Replacement of Relay, RLY01960, with Relay, RLY02557, and Base, BAS01815

Models: CVSF, RTSB

Literature Order Number	PART-SVN04A-EN
File Number	SV-CAP-Controls-Relays-PART-SVN04A-EN-0801
Supersedes	New
Stocking Location	La Crosse

Figure 1 — Typical Wiring of RLY01960, Old

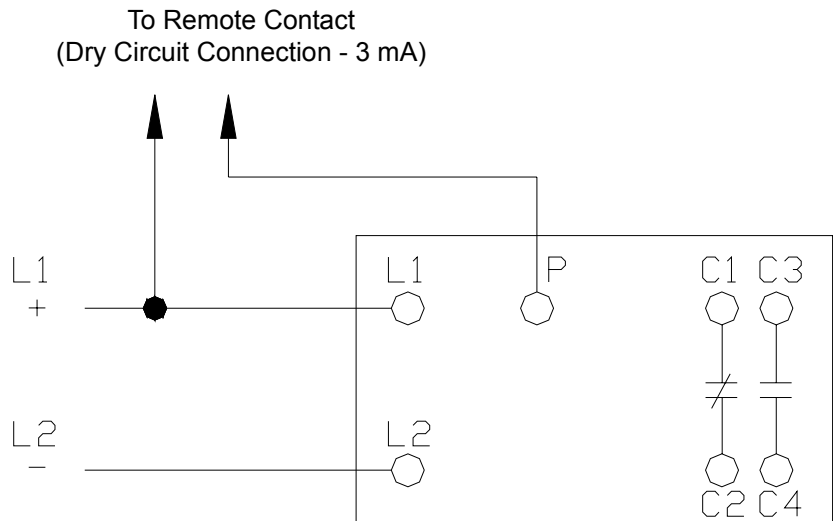
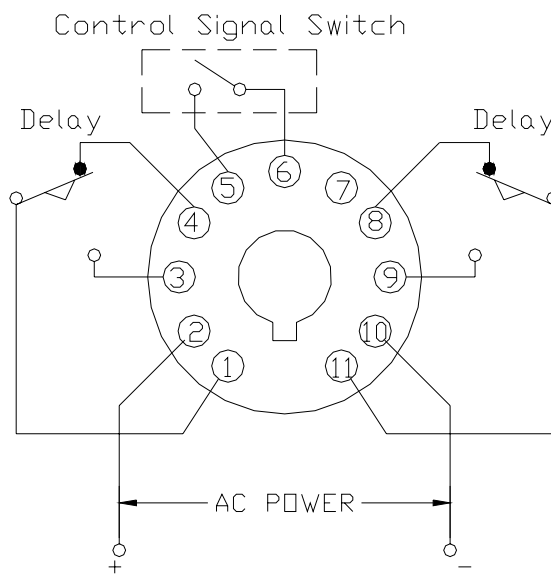
Relay, RLY01960 is obsolete and will no longer be available for purchase. A functional replacement is relay, RLY02557 and base, BAS01815. A few minor modifications will be needed in order for these replacement parts to work properly. Timer Programming Instructions have been included with RLY02557. These instructions must be followed closely for proper operation.

Mount RLY02557 and BAS01815 in a convenient location. New mounting holes will need to be drilled. Remove the leads from RLY01960 and replace them in the corresponding terminals on BAS01815 per Table 1. Not all terminals will be used.

- Operation Mode Group = 2
- Delay on Break
- Time Range Group = 10 minutes

Do not apply voltage to
Terminals 2 and 5
